Resolution of the Direct Containment Heating Issue for All Westinghouse Plants With Large Dry Containments or Subatmospheric Containments

Resolution of the Direct Containment Heating Issue for All Westinghouse Plants With Large Dry Containments or Subatmospheric Containments

Appendix A	Peer Review of NUREG/CR-6338.....	A-1
Appendix B	Melt Mass/Composition Distributions.....	B-1
Appendix C	Plant Geometry.....	C-1
Appendix D	Catalog of IPE Containment Fragility Curves for Operating Pressurized Water Reactors (PWRs).....	D-1

Figure 4.5. Distribution of molten UO_2 in the lower plenum at the time of vessel rupture for Scenarios V and Va.

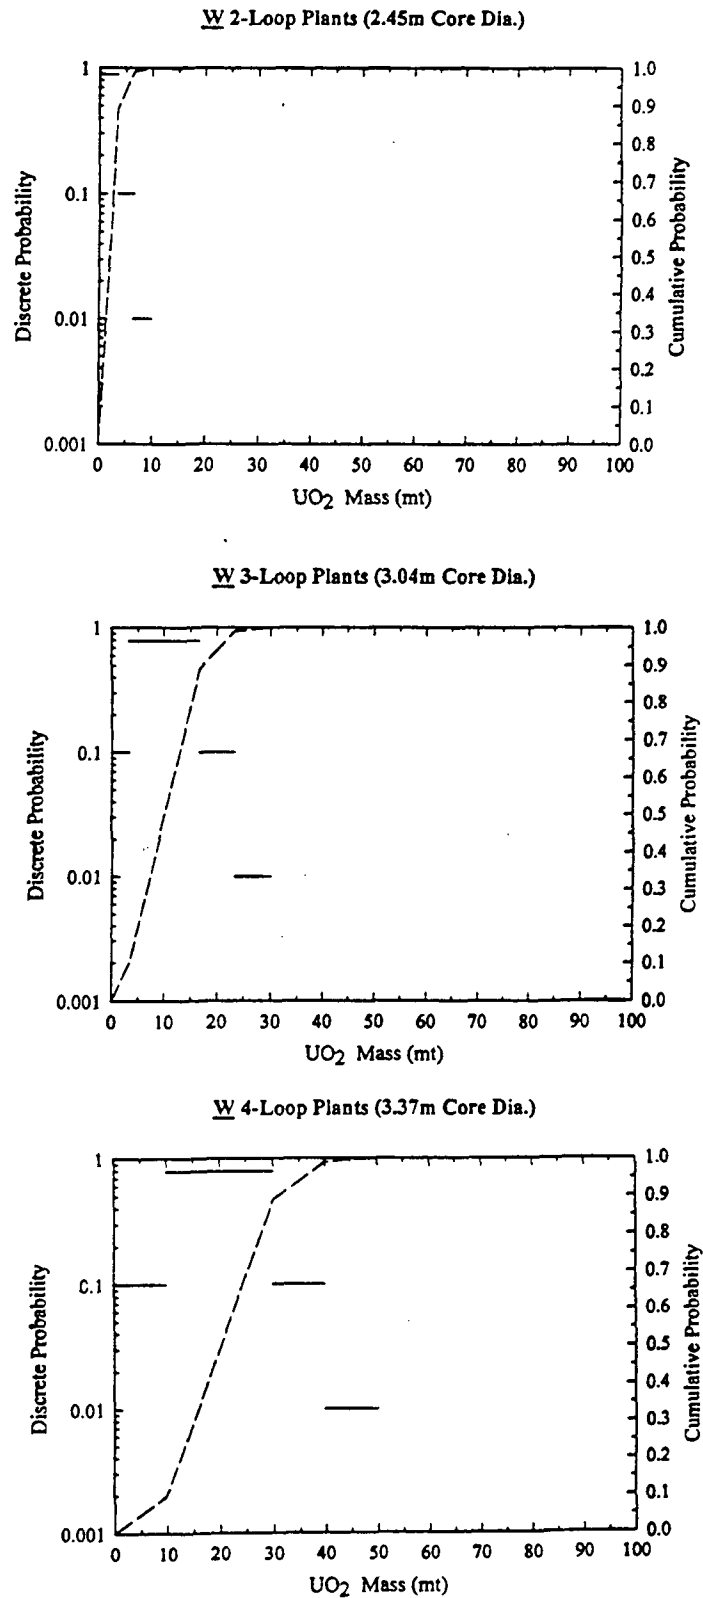
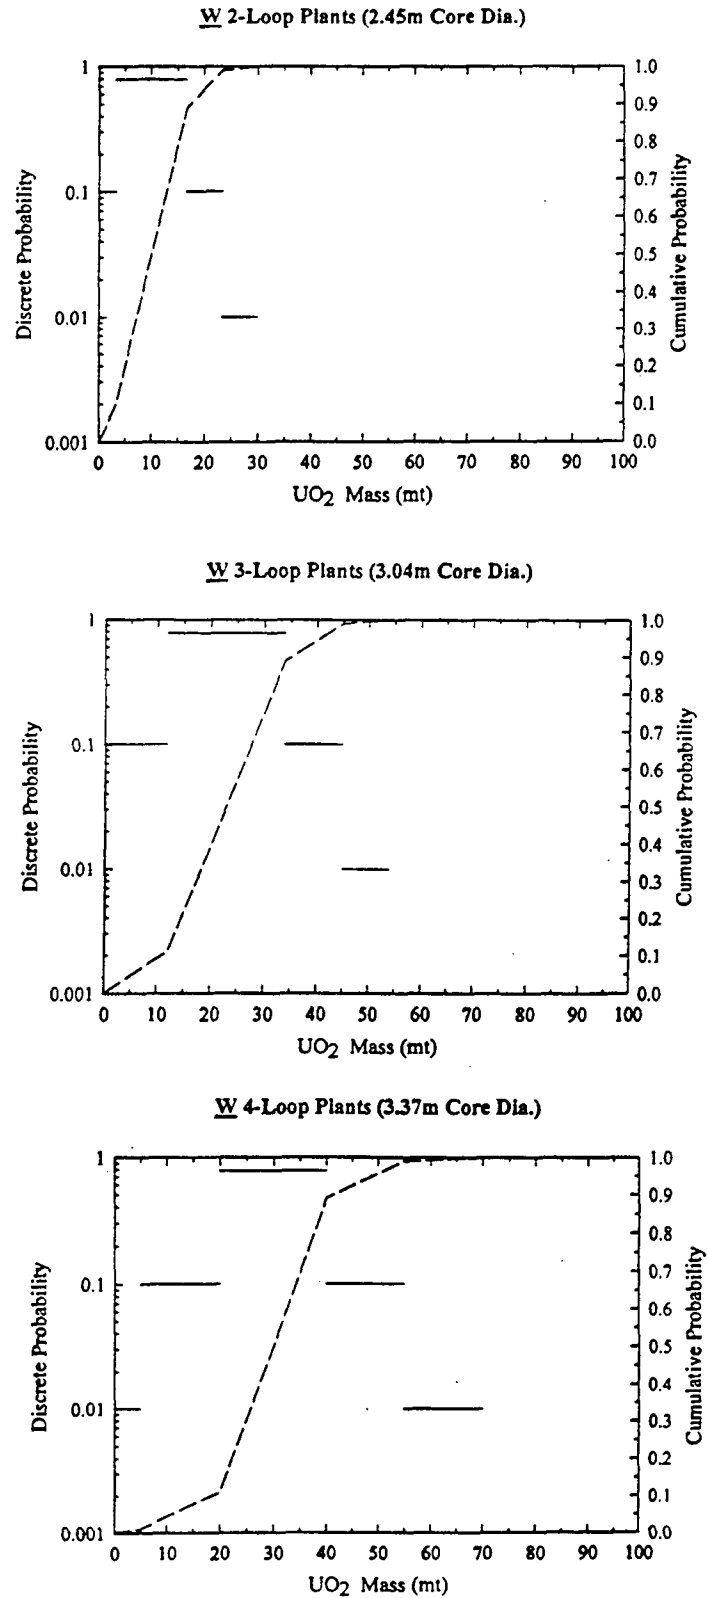
1. A substantial part of the design specific assessment is the extent of molten core debris that is available to be dispersed at the time that the RPV fails. This is given for the three different kinds of RCS designs in Figures 4.5 and 4.7. These result from a simplified geometric argument which is reasonable. To support this, it would be helpful if SCDAP/RELAP5 calculations could be performed for a 2-loop design, in addition to the 3-loop and 4-loop plant results. This would provide the general analytical support for the extent of molten material that exists in the lower plenum at some time after the debris drains into the lower plenum. As an example I would suggest that a time of 1 hour after debris enters the lower plenum be used as a general guide for the interval before RPV failure to analytically support the differences in molten material distributions between the different plants.
